# Technical Service Bulletin

**MODEL(S)  
AFFECTED:**
**Tennant 1510 Automatic Carpet Extractor**

(Models manufactured before Serial Number 90050-10311505 DC1206)

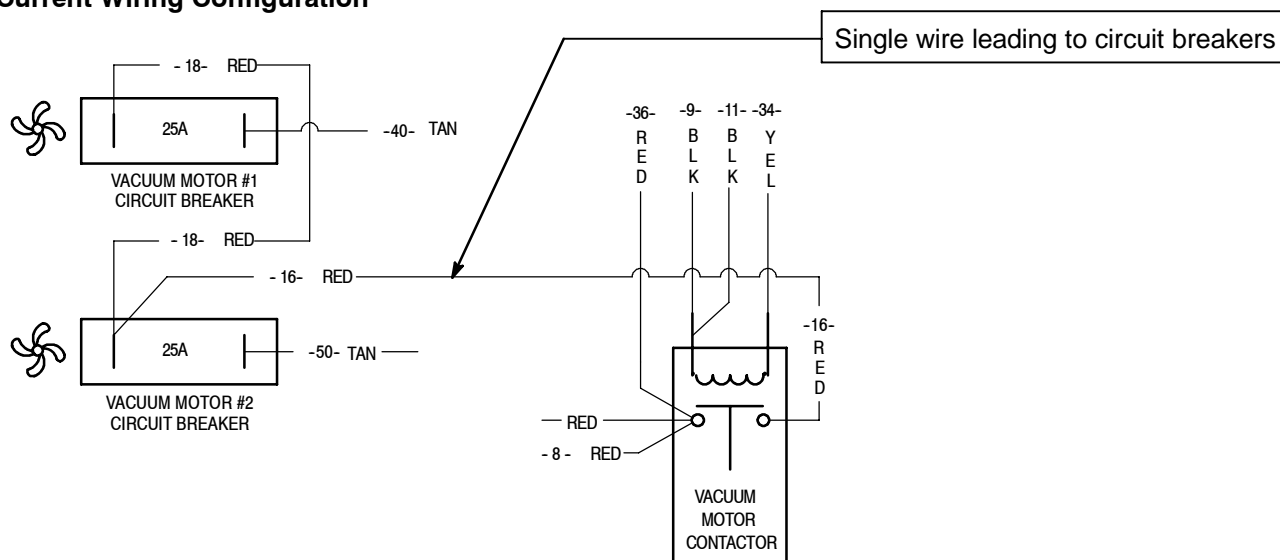
Reports have been received that the wire leading to the vacuum motor circuit breakers may be underrated and may result in frequent tripping and/or minor wire damage.

To prevent frequent circuit breaker tripping and potential wire damage, install Wire Harness Kit (p/n 9003284) shown below. The kit is designed to reduce the current load on the single wire leading to the vacuum motor circuit breakers.
